SUBJECT: River Bend Station, Unit 1
Docket No. 50-458
Supplement to Amendment Request
License Amendment Request (LAR) 2001-43, "High Energy Line
Break Analysis Method"

Supplemental Information

RCIC Pump Room Response To 4" RCIC Line Break

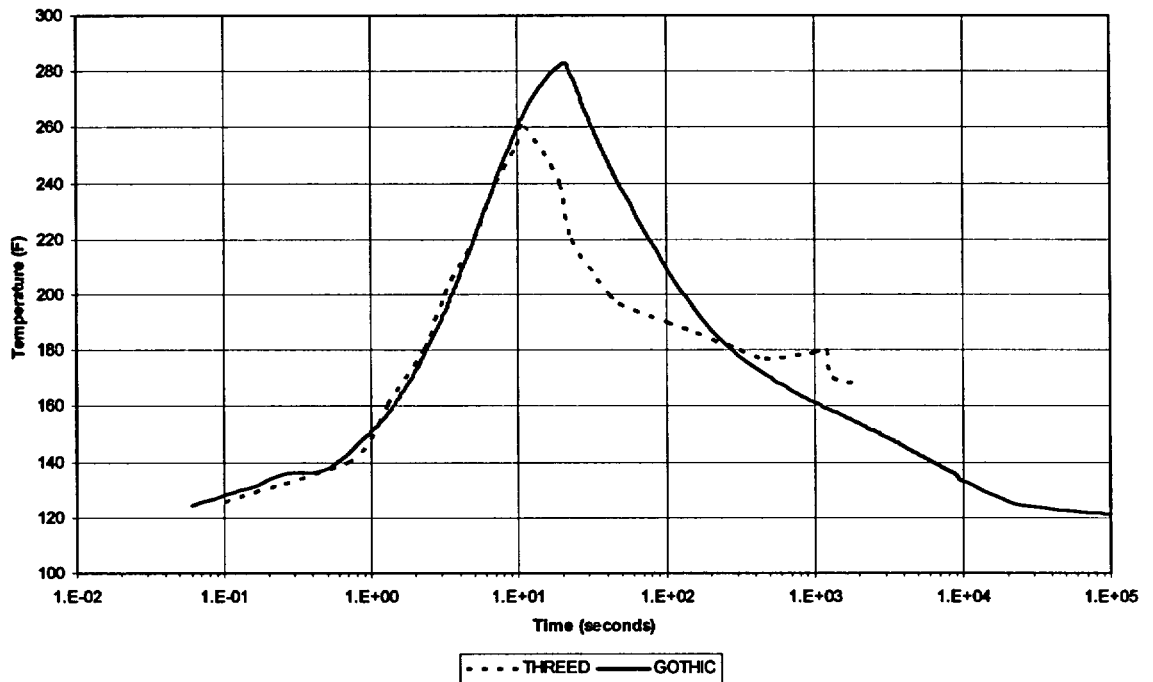
- (b) Provide a comparison of temperature calculation using GOTHIC with a previous calculation for the same case and explain any differences.**

The THREED results are not available in an electronic format. Therefore, a number of points were taken from the graphs found in the original HELB analysis to capture the nature of the RCIC pump room transient temperature response to a break in the 4" RCIC steam line. These points are plotted with the results obtained with GOTHIC in the figure below:

As can be seen the responses are quite similar during the early phase of the event. The differences in the peak values are due to the increase in the time delay assumed prior to initiating isolation of the break. The GOTHIC analysis shows that the room cools down a bit further than the THREED analysis (160 °F versus 180°F at 1,000 seconds). This is due largely to more of the actual Auxiliary Building free volume being modeled in the GOTHIC analysis. The heat is dissipated into the additional volume, thus allowing the temperature to reduce further relative to the THREED results.

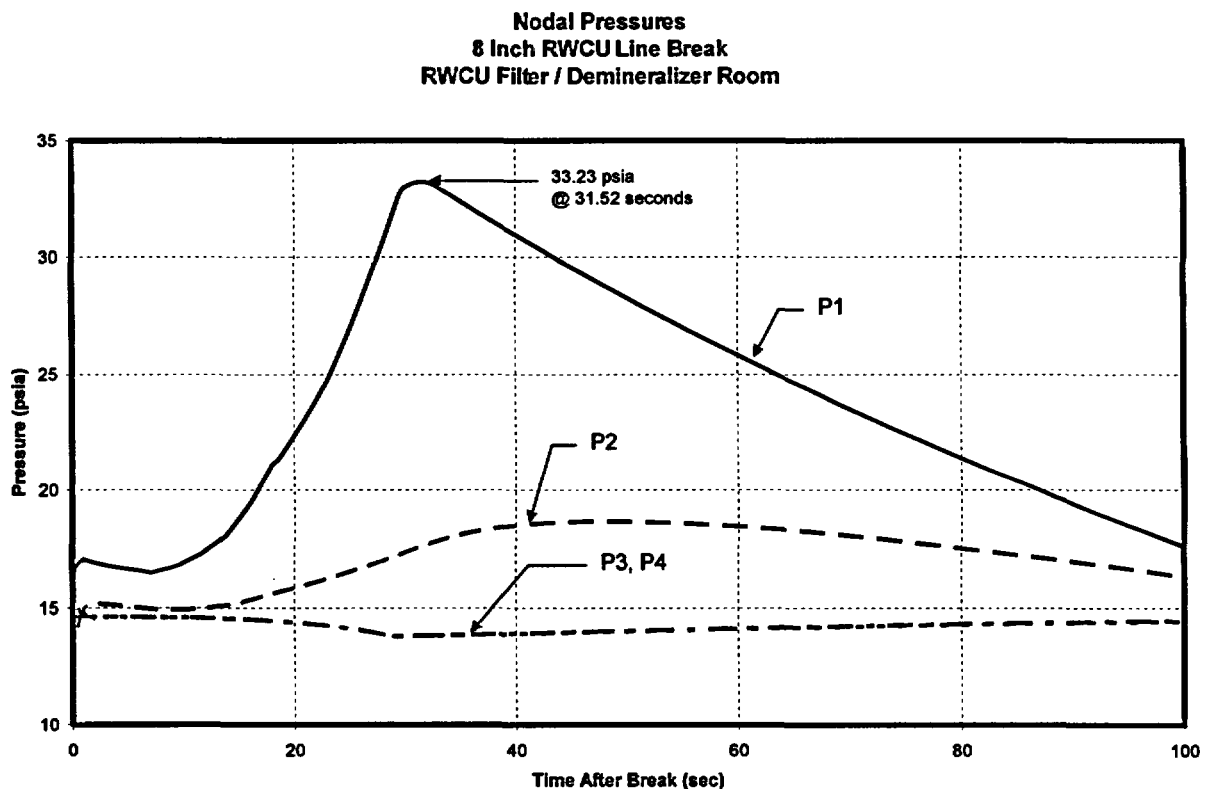
18. **The staff is trying to assess the differences between the currently accepted THREED code and the GOTHIC code for the 8-inch RWCU break. The use of the GOTHIC models appears to reduce the peak pressure (and differential pressure) by about 10 psi.**

CONTAIN analyses were performed by the staff based on the current guidance in the SRP for subcompartment loads analyses. A comparison of CONTAIN to THREED results for the current USAR case shows very good agreement indicating the two models are comparable.

Studies performed by the staff with the CONTAIN code indicate that the new flow paths would have resulted in an increase in the peak pressure of about 1.7 psi based on the mass and energy releases in the current USAR, above 1 psi over the design limit.

With the revised mass and energies and the USAR flow paths, the peak pressure is reduced by about 3.3 psi when compared to the current USAR case.

With the new flow paths and the new mass and energies, the peak pressure is reduced by about 2.3 psi when compared to the current USAR case, about 3 psi below the design limit. The differential pressure is about 2.7 psi below the design limit.

The differences between GOTHIC and CONTAIN appear to be attributed to the models in GOTHIC which allow part of the break mass (and energy) to be directed to a liquid pool and not contribute to the increase in the pressure.

To assist the staff, please perform a GOTHIC analysis which sets the liquid-drop conversion flag to "Ignore." This will provide a basis for understanding the magnitude of this GOTHIC feature.

As requested, the case described above has been run, and a plot of nodal pressures, similar to that provided in the May 14, 2002 letter, is provided here. However, it is the EOI position that the results provided here are for information only, and the results provided in the May 14, 2002 letter represent the "Analysis of Record" for this line break for the reasons discussed in the response to Question 17. Therefore, enabling the drop-to-liquid conversion option is appropriate for breaks involving highly subcooled fluid.

In addition, the peak differential pressure across the RWCU Filter / Demineralizer Room walls was calculated to be 19.417 psid.
